**ADDENDUM TRANSPORT NOTE 2**  
**PROPOSED REDEVELOPMENT (REF: 22/01971)**  
**LAND SOUTH OF ASCOT HIGH STREET**  
**ADL REF: 5235/AM/07A, 7<sup>th</sup> JULY 2023**

**Executive Summary**

Title  
Proposed Station Hill Car Parking (S106)  
(and S278 Highway Works)

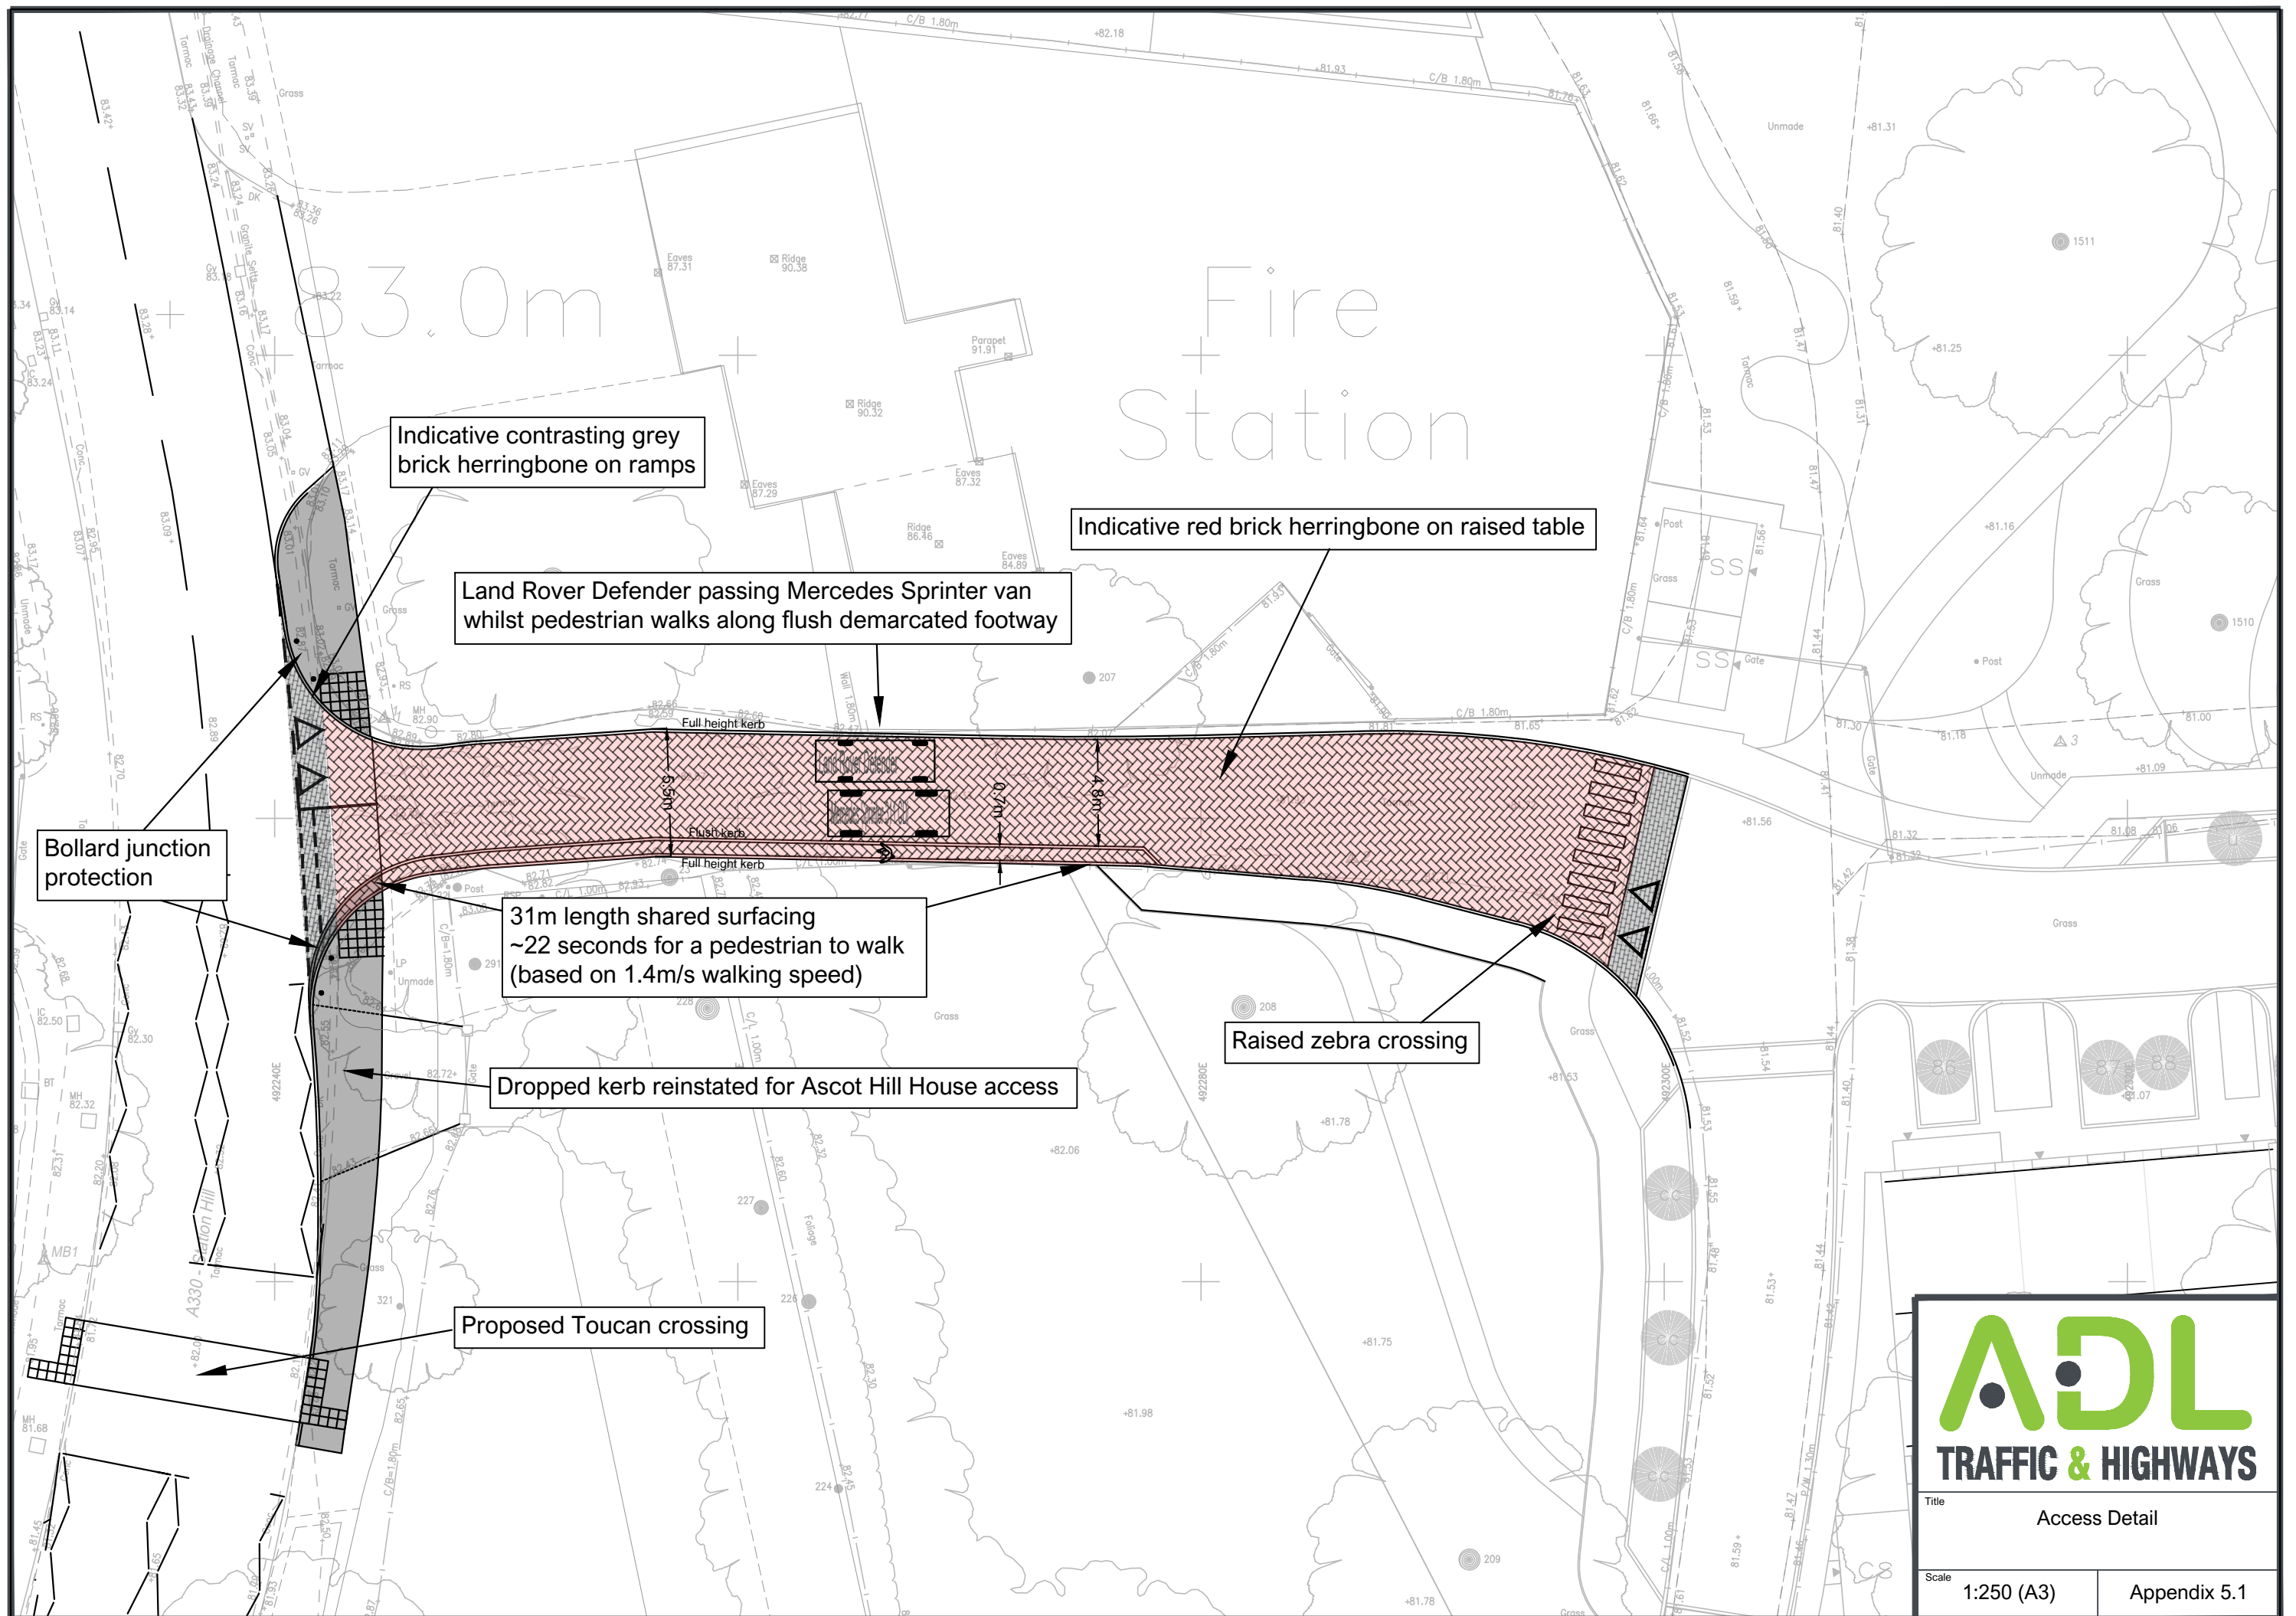
- 4.21 In addition to changing the parking restrictions, ADL have provided a plan which recommends repositioning of the on-street car parking to the west side of Station Hill so that drivers are able to enter and exit their vehicles directly via the footway, rather than the current arrangement where cars are parked adjacent to the carriageway lanes. The amendment would also provide improved visibility between the parking areas and cars travelling on Station Hill.

- 4.22 This suggested improvement offers the opportunity for c.30 short-stay parking spaces and would therefore provide an overall increase of around 14 car parking spaces on Station Hill. In reality, the increase in parking spaces for short-stay car parking availability will be greater than this as the restrictions will also deter cars being parked in this location and left all day.

The drawing provided by ADL (see Appendix 4.0 of ADL's Addendum TN2) indicatively showed 38 new short-stay car parking spaces on Station Hill to benefit the available car parking for the retail / commercial in the local area. This will ultimately be delivered by RBWM, with the Applicant making a S106 highway contribution for the changes.

| <p><b>Design Organisation Response:</b></p> <p>The 'errant parking' will be resolved by the TRO amendments which RBWM would implement as a result of the Applicant's S106 highway contribution for TRO amendments.</p> <p>The contribution will cover the provision of short-stay parking on the west side of the road (outside of the bend) rather than on the inside of the bend, hence improving visibility to parked cars. The new arrangement also allows driver and passenger to alight to the pedestrian footway without needing to cross the road from the parking space as occurs as existing.</p> <p>The contribution will also cover associated costs to more comprehensively cover the associated amendments, such as replacing the existing car parking on the at side of the road (south of the site access) with double yellow lines.</p> |

Title: Access Crossing Distance (Problem 2.1)

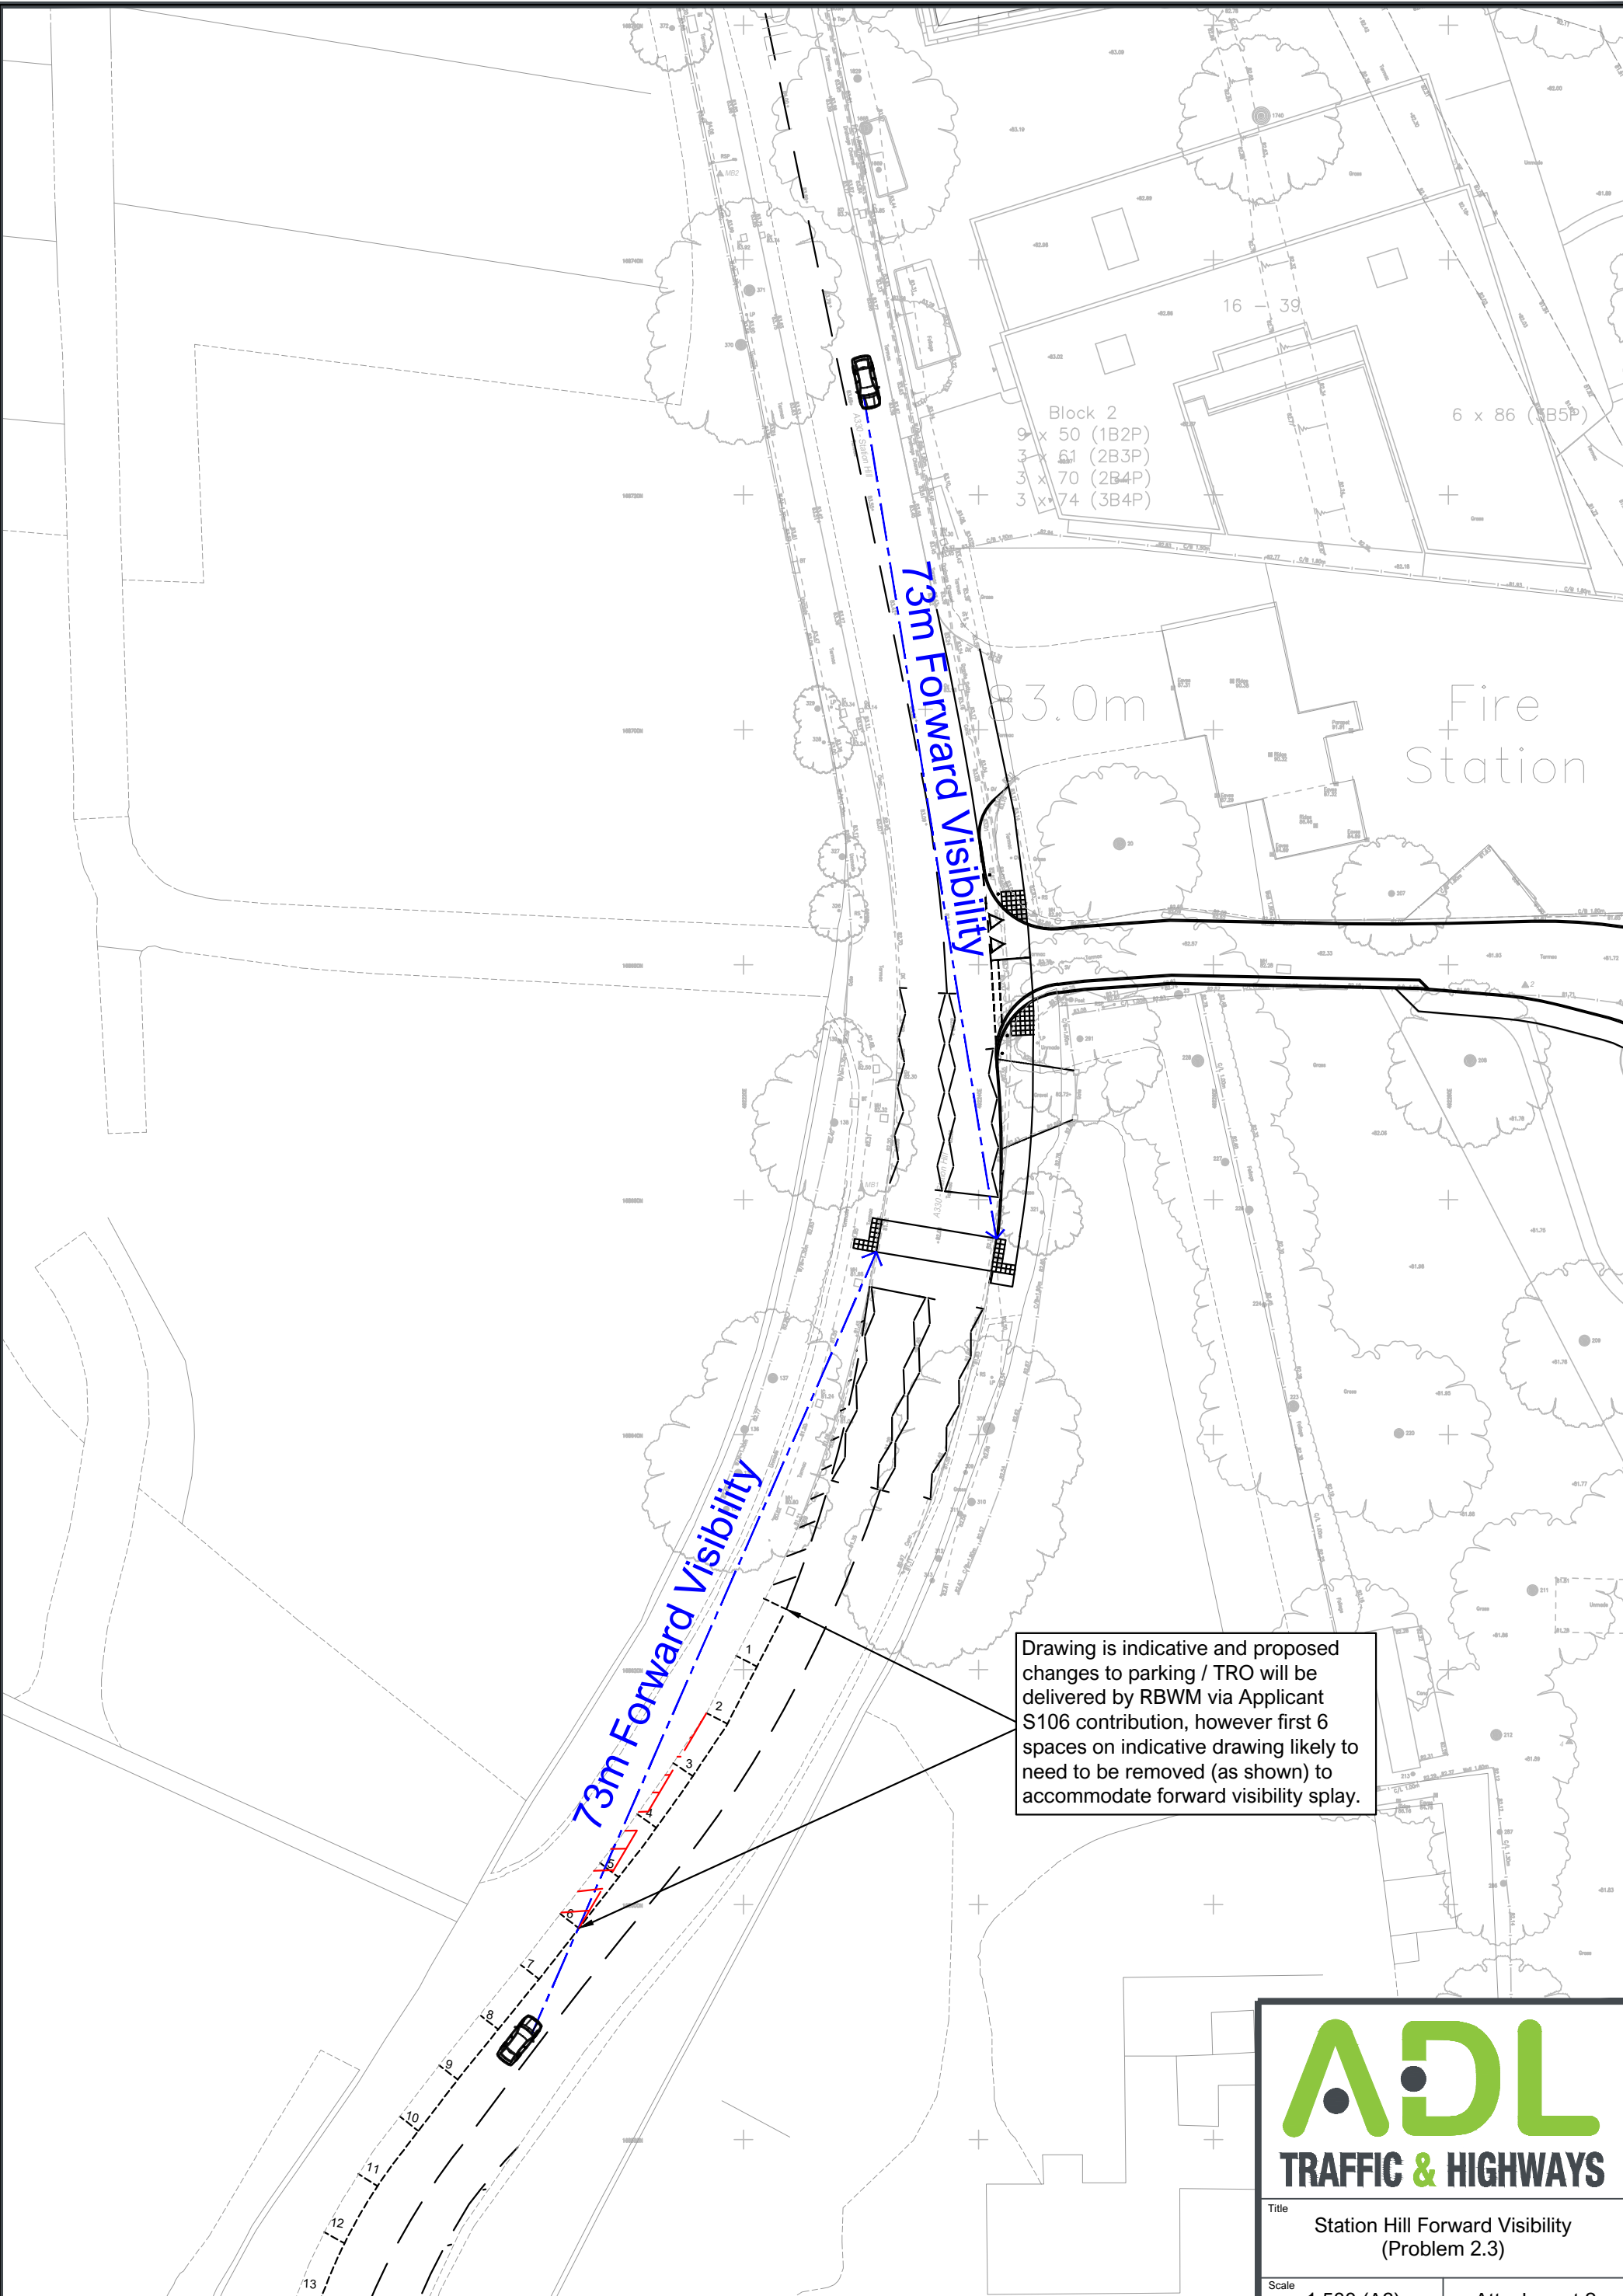
| <p><b>Design Organisation Response:</b></p> <p>The dropped kerb and tactile paving is provided at the narrowest point possible, at the back of footway, inset 1.2m from the edge of carriageway. This is the furthest point in to the site access with respect to the public highway that the crossing can be provided. To inset the crossing into the site access further, the design would be reliant on 3d party land.</p> <p>Notwithstanding this, as shown in Attachment 1, the crossing distance is only 7.45m which would take only 6 seconds to cross based on a typical walking speed of 1.2m/s. This is reasonable, and not excessive.</p>      |
